Work Order ID 96774

Item Name: Crosstube Turning Detail

DART AEROSPACE LTD	Work Order:	96774
Description: Crosstube Assembly (412 High Aft)	Part Number:	D412-664-243
Inspection Dwg: D412-664-243 Rev: E		Page 1 of 2

DRAWING NO. D412-664-243	TITLE CROSSTUBE ASSEMBLY (412 HI AFT)	REV. E	DART AEROSPACE LTD ENGINEERING ORDER		D.E.O. NO. D412-664-243-E-1	SHEET NO. SHEET 1 OF 2	SCALE NTS
DRAWN	CHECKED	MFG. APPR.	APPROVED	DE APPR.			
DATE 11.03.31	DATE 11/03/31	DATE 11.03.31	DATE 11/03/31	DATE 11-03-31

**D412-664-243
ASSEMBLY DETAIL**

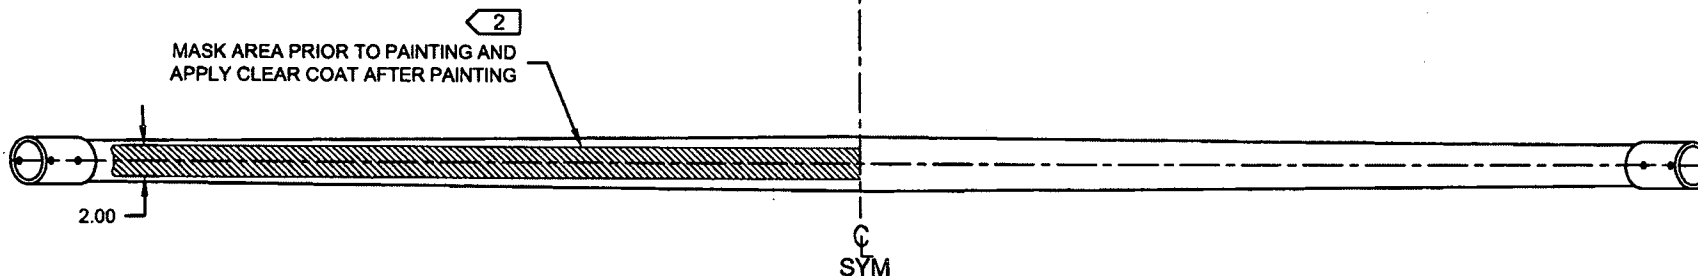
REMOVED ABRASION STRIP IN FAVOR OF A THIN LAYER OF PROSEAL 890.

IS:

D3189-1 CHAFING SHIELD (1, INSTALLED OVER PROSEAL 890)
MS21920-28 CLAMP, 2X
2 PL

WAS:

D2856-600-1009 ABRASION STRIP
D3189-1 CHAFING SHIELD (1, INSTALLED OVER ABRASION STRIP)
MS21920-28 CLAMP, 2X
2 PL

MASK AREA PRIOR TO PAINTING AND
APPLY CLEAR COAT AFTER PAINTING

**D412-664-243
ASSEMBLY DETAIL**

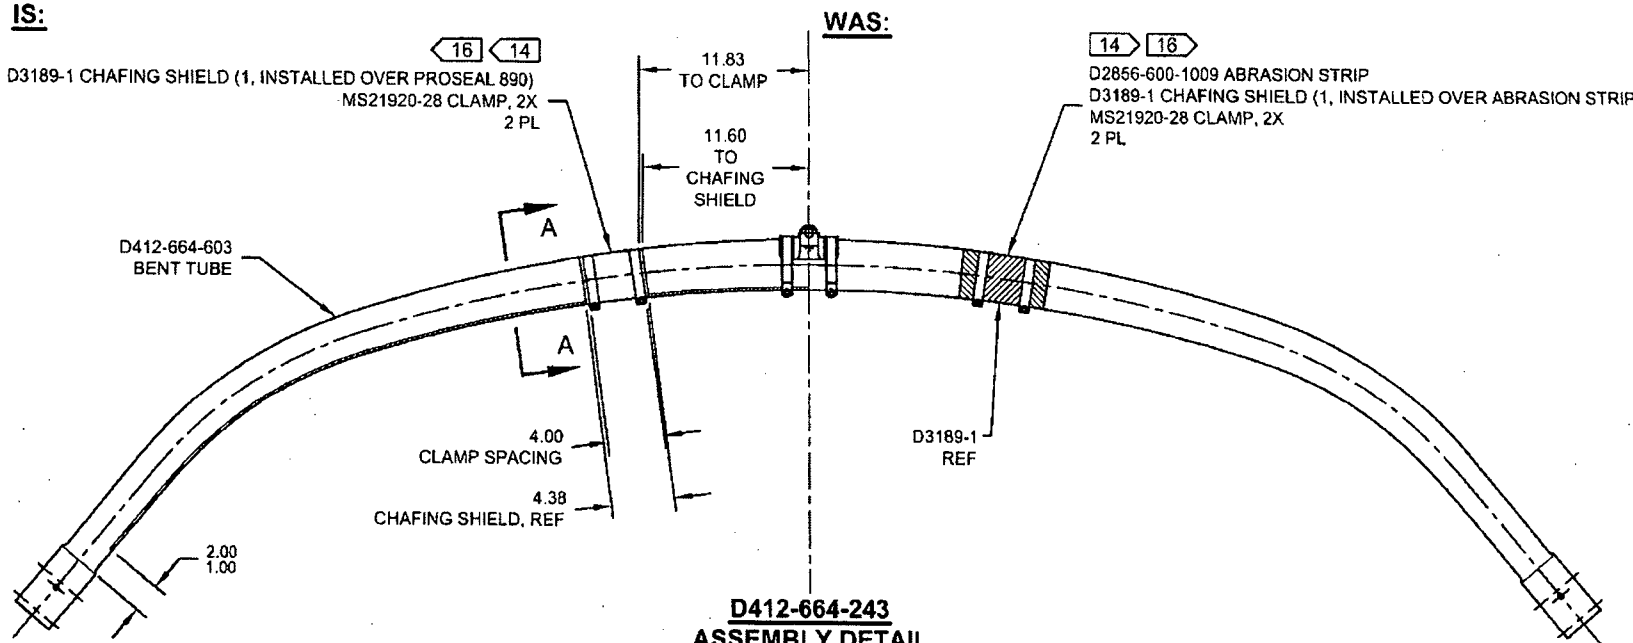
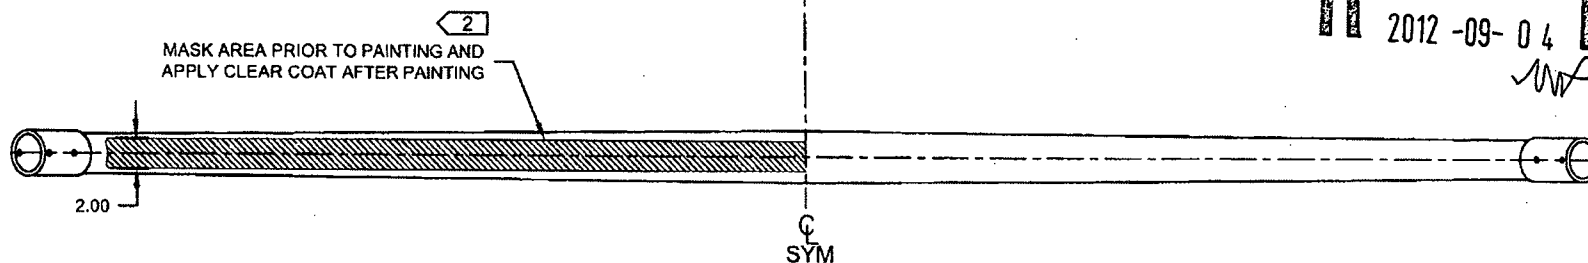
REMOVED ABRASION STRIP IN FAVOR OF A THIN LAYER OF PROSEAL 890. UPDATE INSTALLATION OF CHAFING SHIELDS AND REDUCE TORQUE TO 40-50 IN-LBS. THIS ENGINEERING ORDER SUPERCEDES DEO D412-664-243-E-1.

IS:

D3189-1 CHAFING SHIELD (1, INSTALLED OVER PROSEAL 890)
MS21920-28 CLAMP, 2X
2 PL

WAS:

D2856-600-1009 ABRASION STRIP
D3189-1 CHAFING SHIELD (1, INSTALLED OVER ABRASION STRIP)
MS21920-28 CLAMP, 2X
2 PL

SECTION A-A
CHAFING SHIELD DETAIL
VIEW ROTATED, NOT TO SCALE

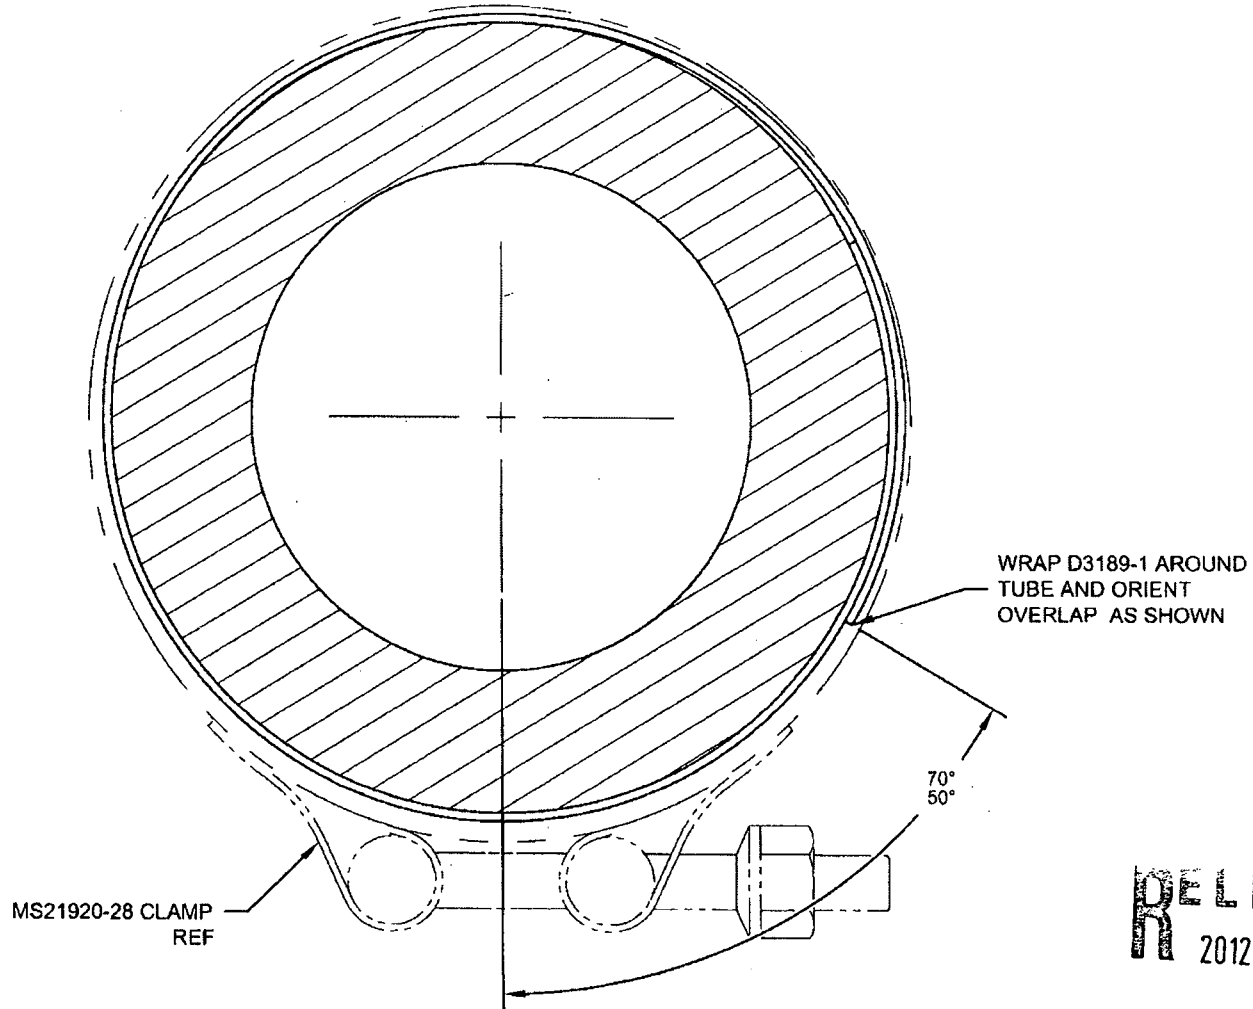
- 2) FINISH: CHEMICAL CONVERSION COAT PER DART QSI 005 4.1
PRIME INSIDE AND OUTSIDE PER DART QSI 005 4.2
MASK UNDERSIDE OF CROSSTUBE AS SHOWN (HATCHED AREA)
PAINT OUTSIDE PER DART QSI 005 4.2
AFTER PAINTING, APPLY CLEAR COAT ON HATCHED AREA
- 14) APPLY A THIN COAT OF PROSEAL 890 ON INSIDE CONCAVE SURFACE OF D3189-1 CHAFING SHIELD AND LET CURE PER MANUFACTURER'S INSTRUCTIONS. INSTALL PROSEALED D3189-1 CHAFING SHIELD ONTO CROSSTUBE BY APPLYING A THIN COAT OF PROSEAL 890 ONTO CROSSTUBE. BE SURE TO ELIMINATE ANY AIR GAPS.
- 16) TORQUE CLAMPS ON D2896-1 SUPPORT 80 TO 100 IN-LB. **TORQUE CLAMPS ON D3189-1 CHAFING SHIELD 40 TO 50 IN-LB.** ENSURE AT LEAST 1.5 THREADS SHOWING IN SAFETY AND THAT NUT HAS NOT BOTTOMED-OUT AFTER TORQUING.
